#### TRANSMITTAL SHEET FOR NOMAD SERVICE BULLETIN

SERVICE BULLETIN NO: NMD-52-7

Doors - Aft Passenger Door - Improved Mechanical Stop

(Modification N638)

Re-Inforcing of Aft Passenger Door Figure 1

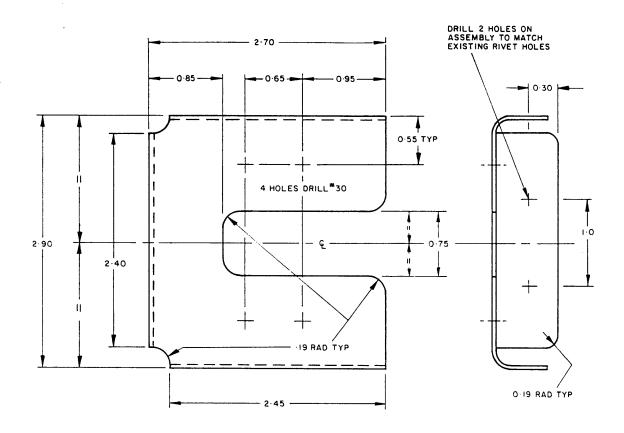
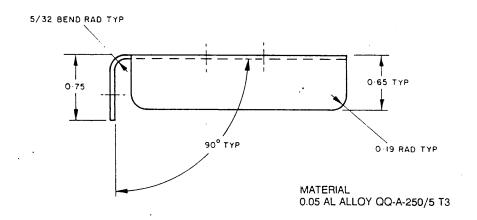
The under side of the diaphragm is strengthened by the addition of a re-inforcing bracket and angle.

- A. Remove the lower trim from the passenger door.
- B. Drill out the two rivets as shown in Figure 1 View on Arrow B. Inspect area around rivet holes for any signs of cracking. If the area is cracked, stop drill using a 1/8 in dia drill.
- C. Make a bracket 1A/N-11-1377SB and angle 1B/N-11-1377SB as shown in Figs 2 and 3 respectively.
- D. Position the bracket and angle and, using the bracket and angle as templates, drill rivet holes in the diaphram and door frame with a #30 drill. Using a  $\oint$  2.45 mm drill, drill out two rivets from the outer skin to match the bracket as shown in Figure 1. Deburr all holes.
- E. Rivet bracket and angle to diaphram using MS20470AD4-5 rivets. Rivet bracket to outer skin using MS20426AD3-5 rivets and angle to door frame using MS20470AD4-5 rivets.
- F. Clean all swarf from inside door. Alodine and epoxy prime any bare metal.

Bracket Manufacturing Details Figure 2

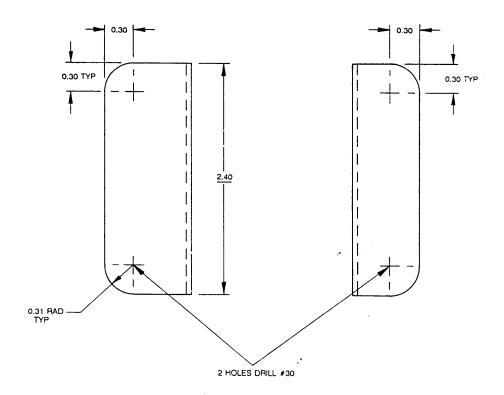
PART NUMBER IA/N-II-1377 SB

Note 1: CR 3213-4-2 is also an acceptable alternative Note 2: Made from 0.050 inch Al Alloy QQ-A-250/5 T3
